90-102 Regent Street Modification 1

Internal and external amendments and replacement of
condition of consent relating to land dedication
State Significant Development Modification Assessment
(SSD 10382 MOD 1)

July 2022

Figure 3 | Comparison of floor to ceiling heights and sprinkler head servicing for parts of Levels 2-18
(Source: AJ&C)

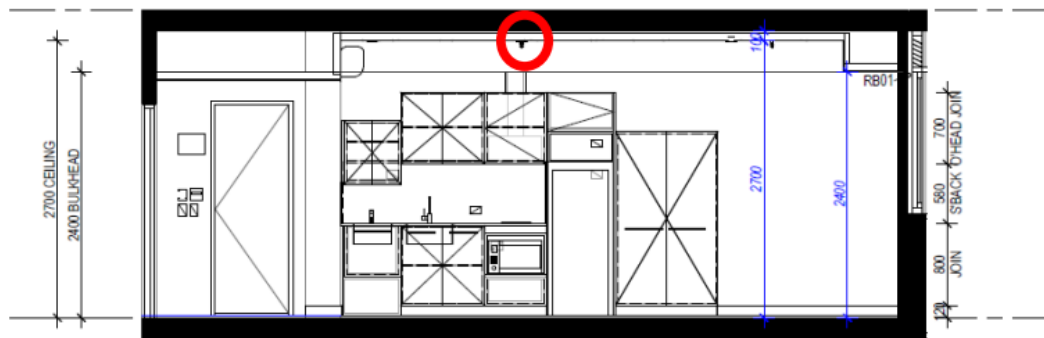
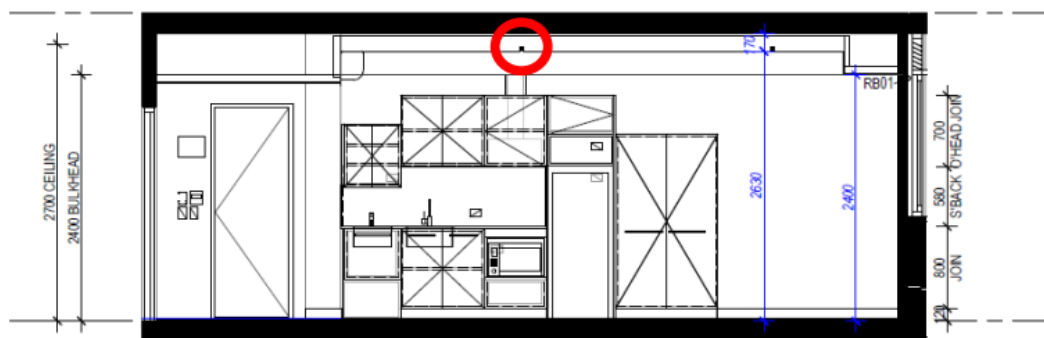
Issue	Findings	Recommendations
Reduced Ceiling Heights	<ul style="list-style-type: none"> • The modification seeks to reduce floor to ceiling heights by constructing sprinkler heads flush (or concealed) within the ceilings. The modified floor to ceiling heights include: <ul style="list-style-type: none"> ○ Level 2: 7 x sole-occupancy units have a ceiling height of 3m (reduction of 400mm). The remaining SOUs have a height of 3.4m. ○ Levels 3 – 18: 2.63m (reduction of 70mm). • The Department considers that the above changes are necessary for servicing, and that the affected rooms remain capable of complying with the minimum floor to ceiling heights specified in the Building Code of Australia. 	<p>The Department recommends:</p> <ul style="list-style-type: none"> • Condition A2 be updated to reflect the amended plans.
Other Internal Changes	<ul style="list-style-type: none"> • The modification seeks to make internal floorplan amendments, including: <ul style="list-style-type: none"> ○ the ramp design from the loading dock on the Lower Ground Floor, while retaining the approved grade ○ the detailed design of the waste storage room on the Lower Ground Floor and the waste rooms on Levels 2-18 of the building to correspond with Council's comments on the Operational Waste Management Plan being prepared in accordance with Condition B70 of the consent ○ incorporate the lobby for the bike hoist into the bike storage room, providing more direct 	<p>The Department recommends:</p> <ul style="list-style-type: none"> • Condition A2 be updated to reflect the amended plans

Figure 4 | Comparison of the eastern elevation including the public artwork, mechanical exhaust and louvres, and the terrace balustrade glazing (Source: AJ&C)

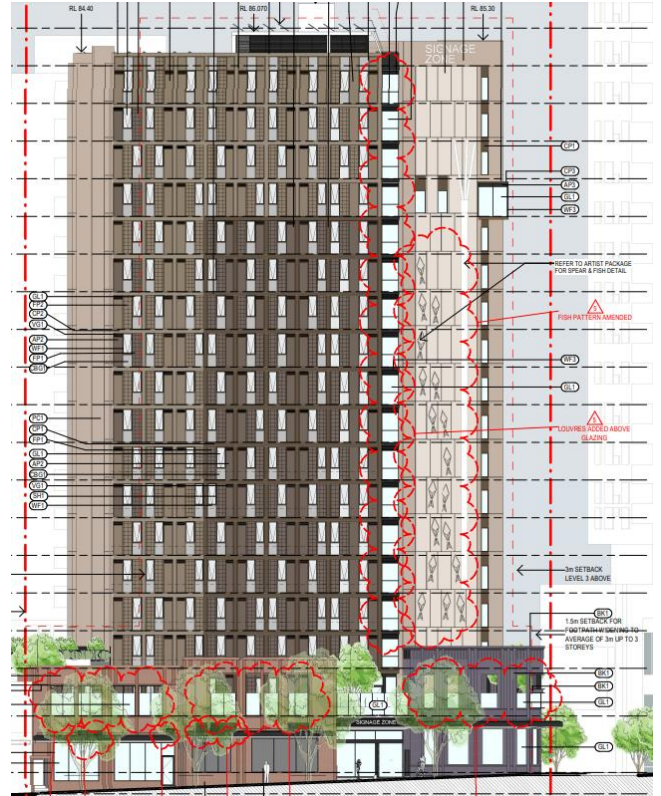
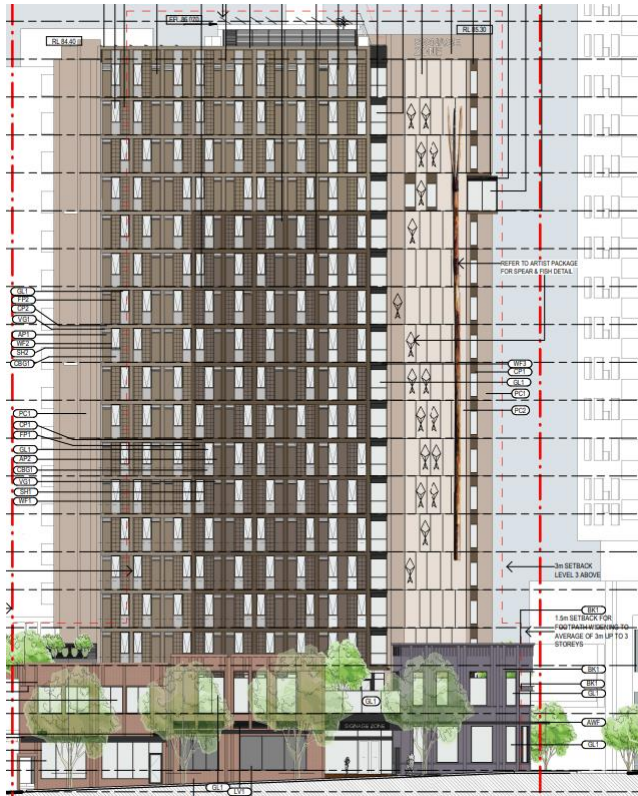
- The approved development incorporates public art mounted to the north-eastern corner of the building.
- This modification seeks to amend the public artwork to reflect an updated design by the Artist, as supported in a statement from the Artist.
- The Department accepts the above changes, noting that Condition B68 requires further resolution of public art through the preparation of a Public Art Strategy in consultation with Council.

Level 2 Terrace	<ul style="list-style-type: none"> • The approved development provides a communal terrace on Level 2 of the building for students. This terrace is enclosed by 2.5m glazing, in addition to a glass canopy above. • The modification seeks to reduce the height of the glazed balustrade for the Level 2 terrace from 2.5m to 1.8m. • The Department accepts the revised balustrade height as it does not materially affect wind or noise mitigation and compliance with Conditions B14 or B52 of the consent. • The Department also notes the terrace will be managed in accordance with an Operational Plan of Management to be prepared in accordance with Condition E4 of the consent. 	<p>The Department recommends:</p> <ul style="list-style-type: none"> • Condition A2 be updated to reflect the amended plans • Condition B14 be amended to reference the supplementary wind assessment provided with the application.

- Condition A2 be updated to reflect the amended plans.

Figure 5 | Comparison of the western elevation, including mechanical exhaust and louvres, garage door, and the terrace balustrade glazing (Source: AJ&C)

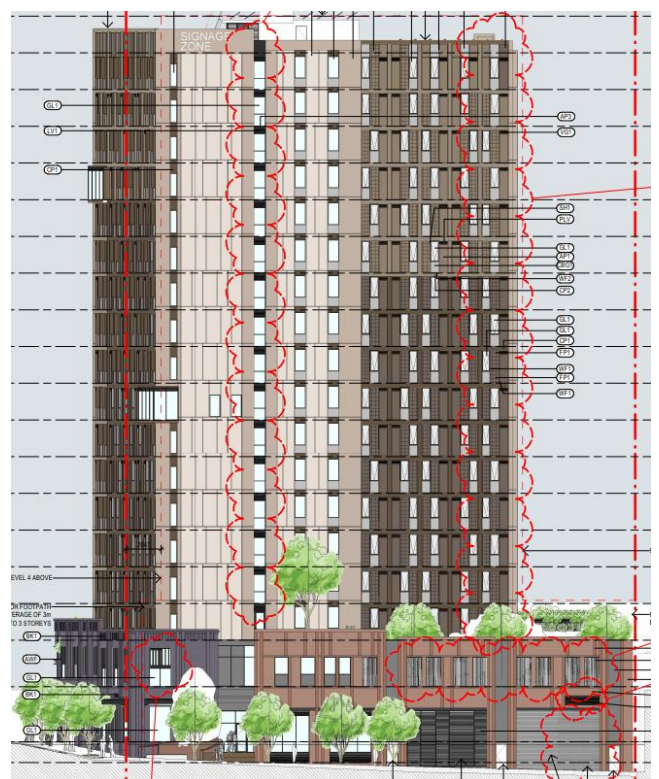
Other External Changes	<ul style="list-style-type: none"> • The modification seeks to make amendments to the external appearance of the development comprising: <ul style="list-style-type: none"> ○ amending the window configuration on the eastern and northern facades ○ reconfiguring the privacy louvres on the western façade of Level 2 ○ providing mechanical louvres on the eastern, western, and southern elevations to support the natural ventilation of residential corridors ○ moving the position of mechanical exhaust louvres for Levels 1 and 2 to respond to detailed design servicing requirements ○ changing the materiality of the loading dock garage door from a solid finish to 50% perforated metal to support the natural ventilation of the basement ○ realigning the existing basement wall as shown on the plans and adding plenum walls in the north-east corner of the basement to align with the demolition survey of the site. • The Department notes that works will need to comply with the separate Sydney Metro and TfNSW requirements detailed in the conditions of consent. • The Department concludes that the proposed modifications are acceptable as they will not materially impact the appearance or overall design 	<p>The Department recommends:</p> <ul style="list-style-type: none"> • Condition A2 be updated to reflect the amended plans
